ADDENDUM NO. 1 TO BID NO. 13-0107-4

FOR: CLOVERDALE COMMUNITY CENTER

PLEASE SEE THE FOLLOWING FOR ADDITIONS, CLARIFICATIONS AND/OR CHANGES:

TYPICAL BUILDING SECTION
1/2" = 1'-0"

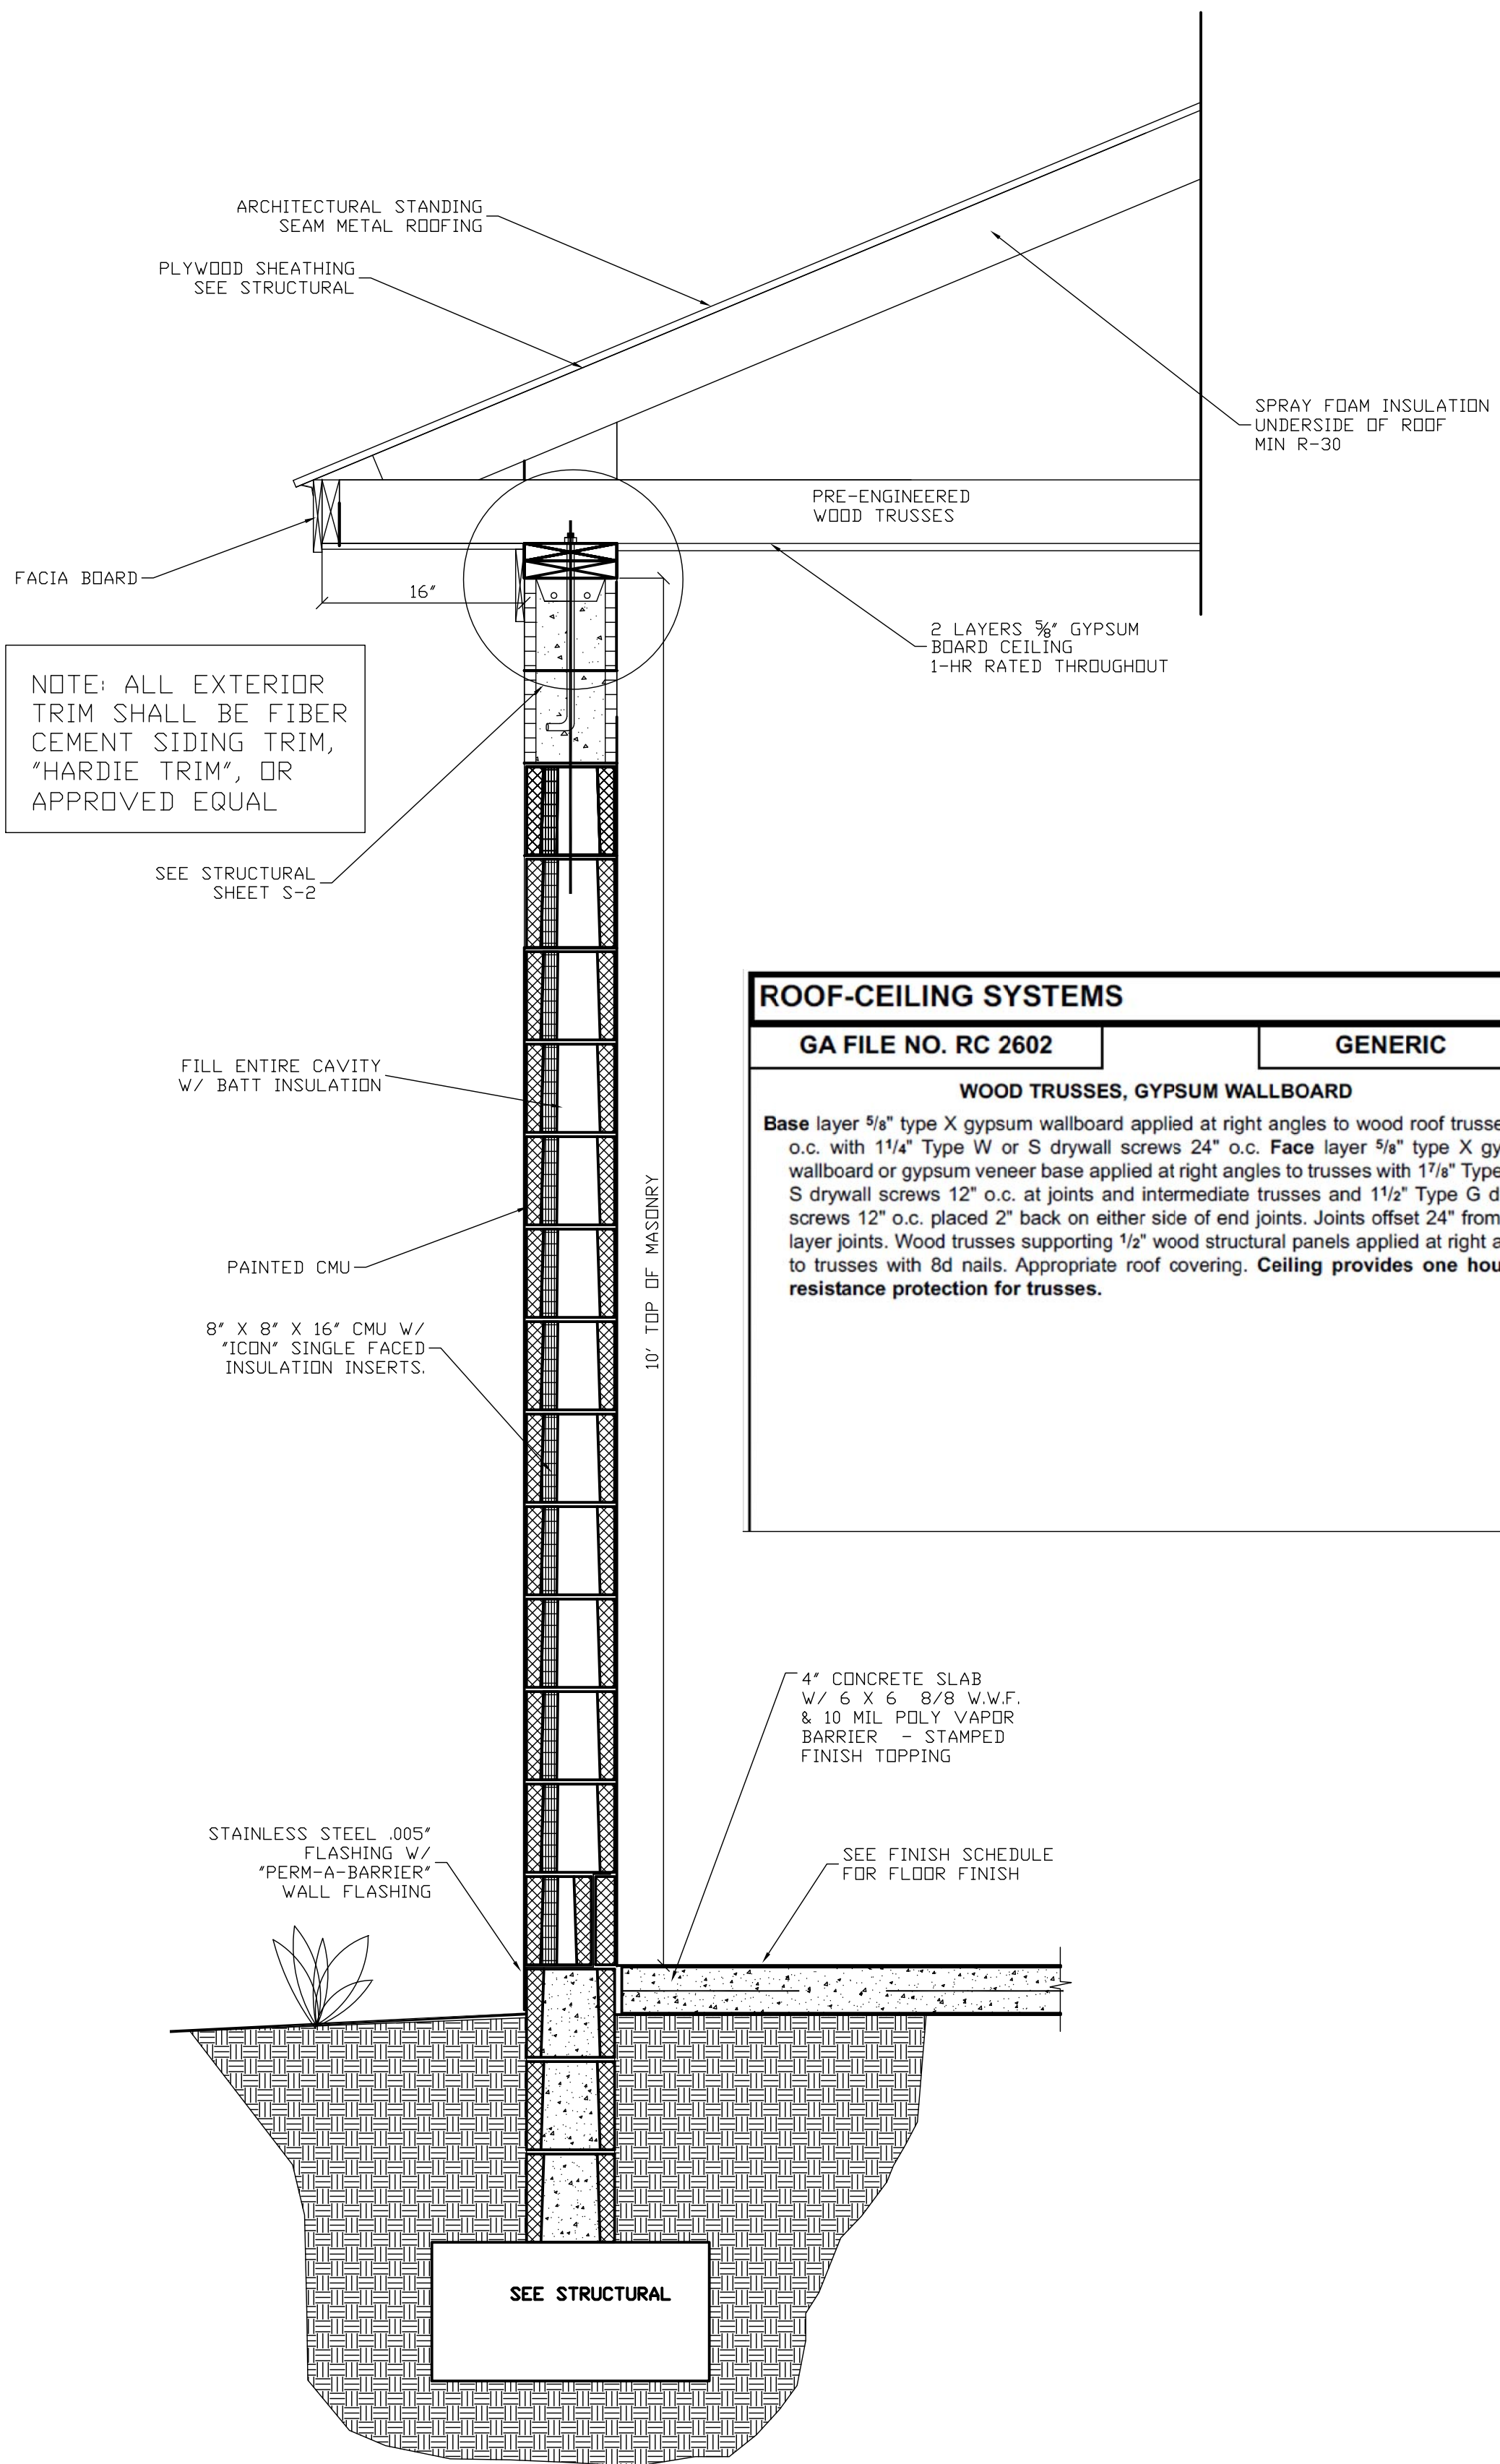
3. Q) What is the hardware to be for the aluminum storefront doors ?

A) *Entrance storefront hardware: See revised sheet A-3. Mid-rail, flush panic device with manufacturer provided locking.*

A
P-1 WASTE RISER DIAGRAM
SCALE: NTS

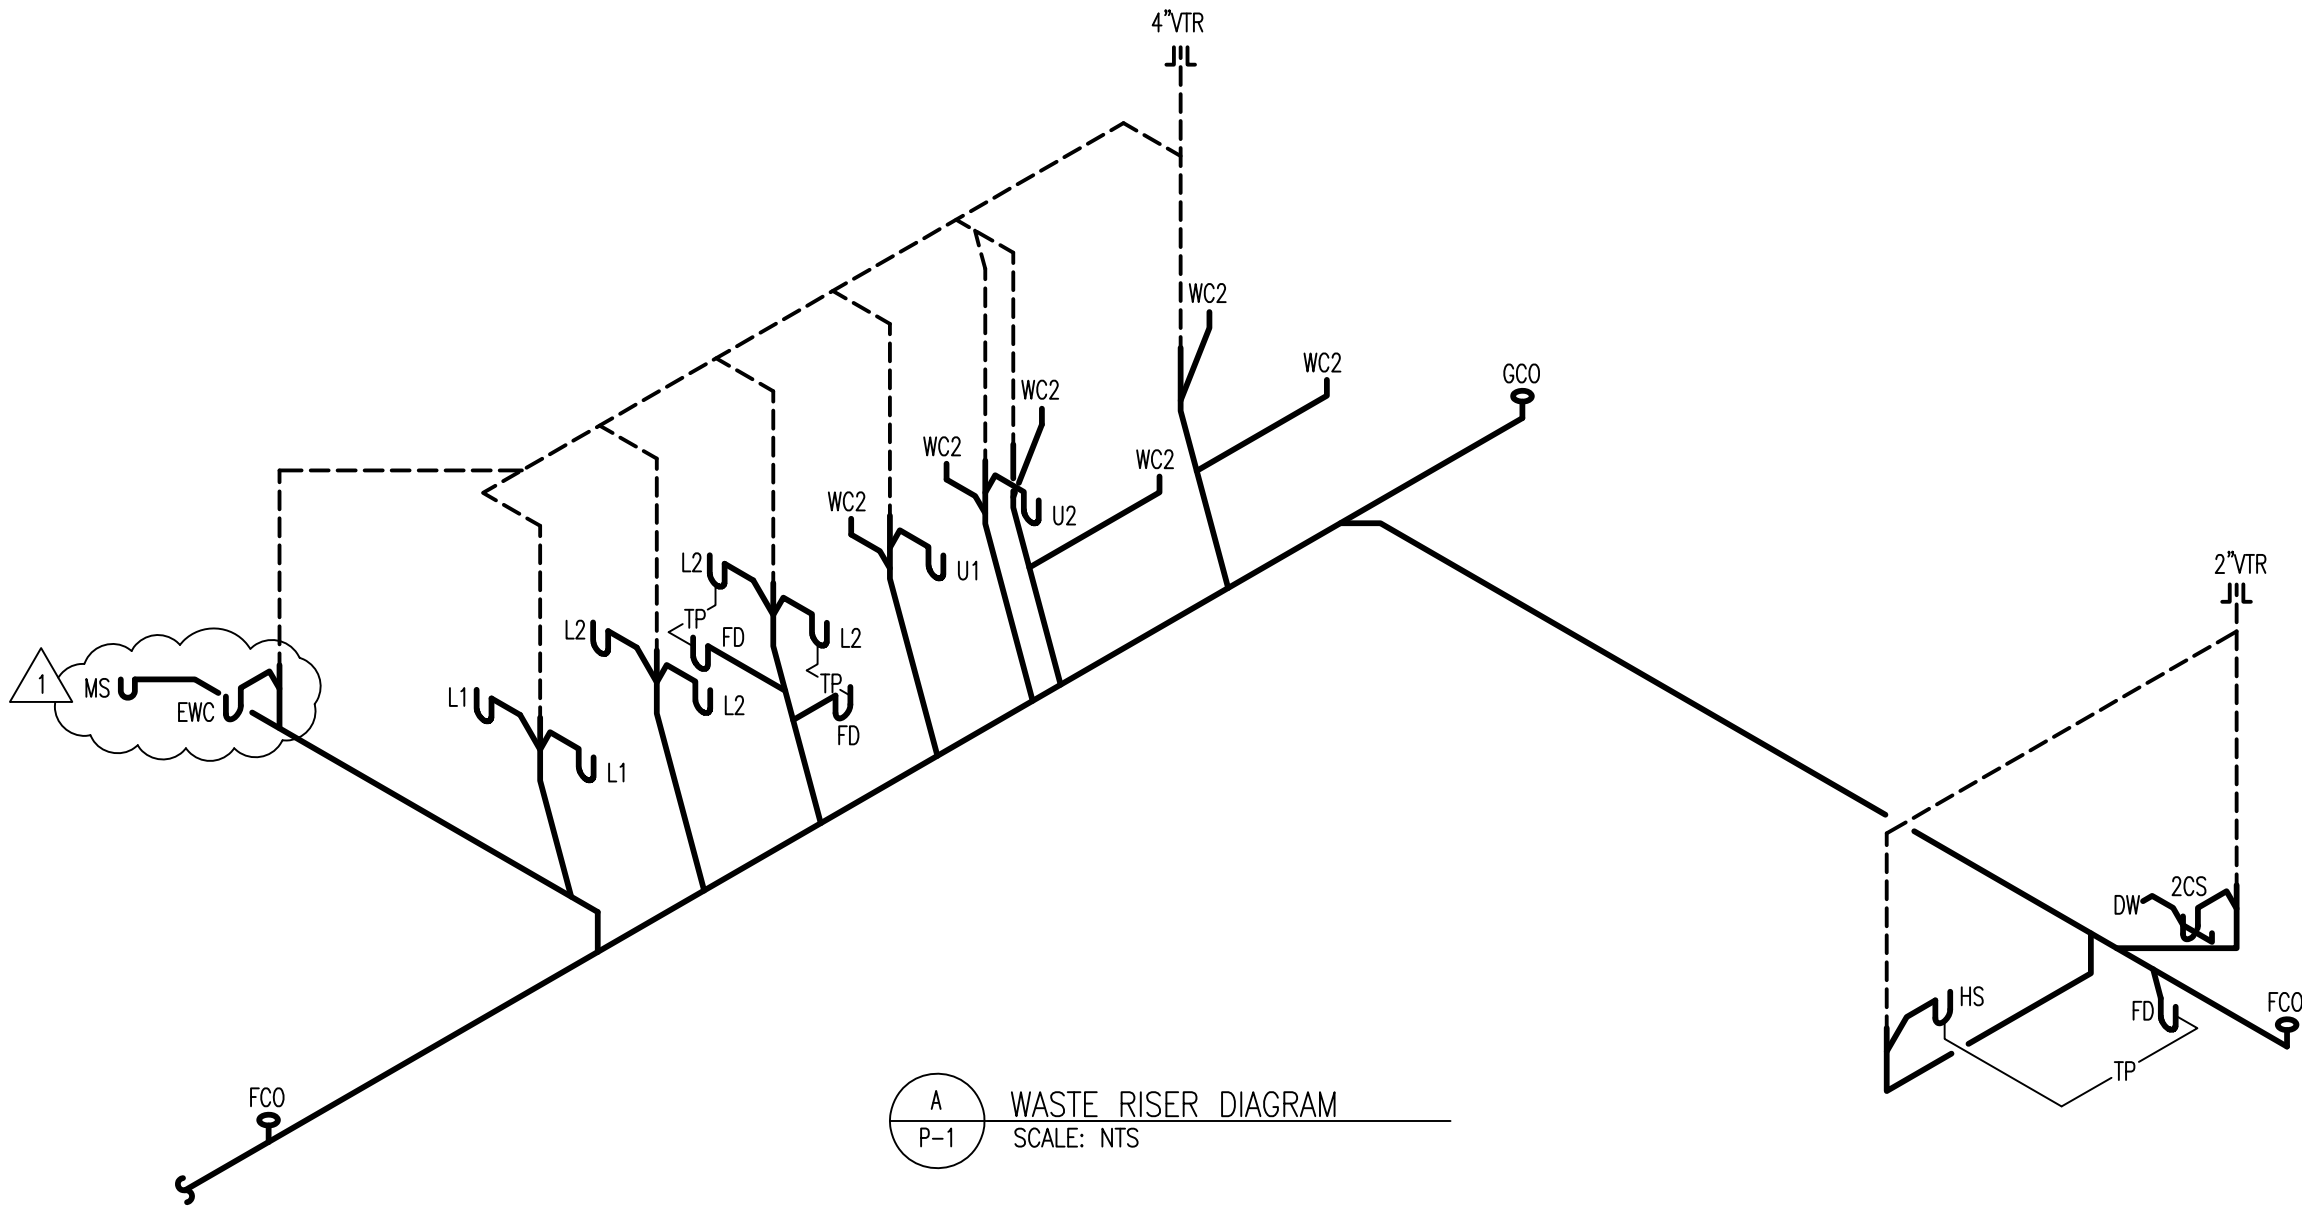
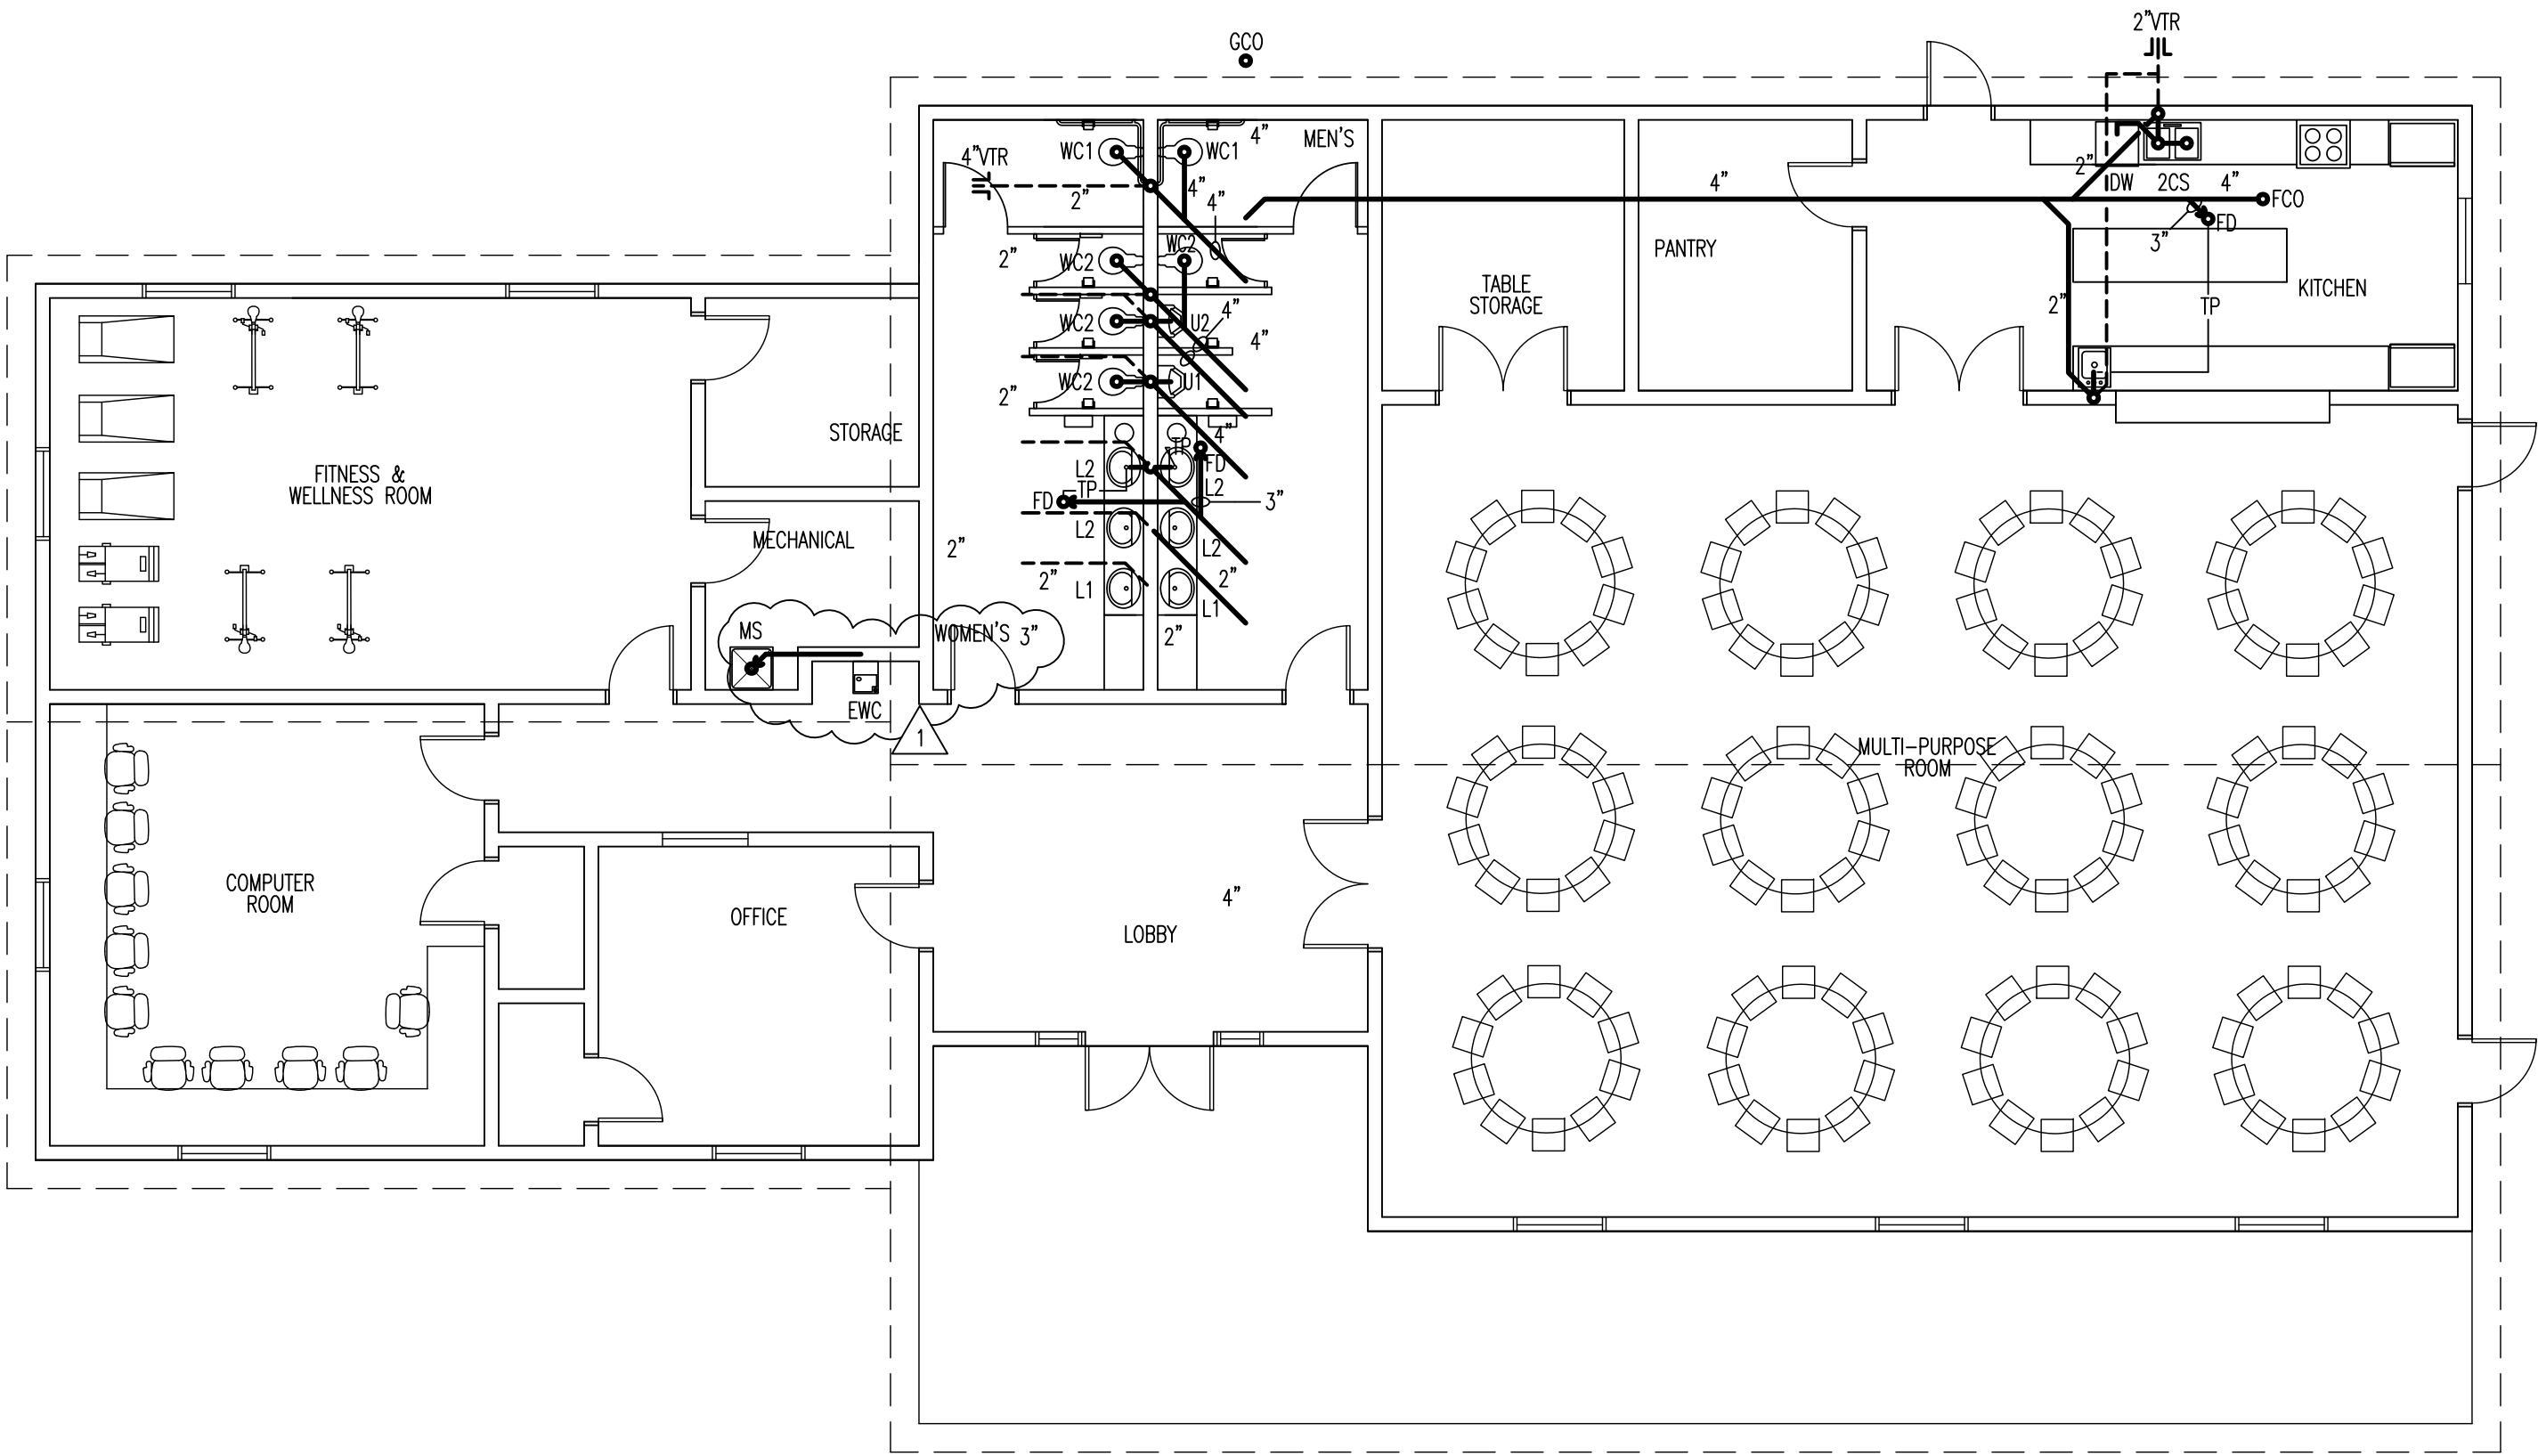
Waste Water Diagram:

Change “2CS to read 3CS”.
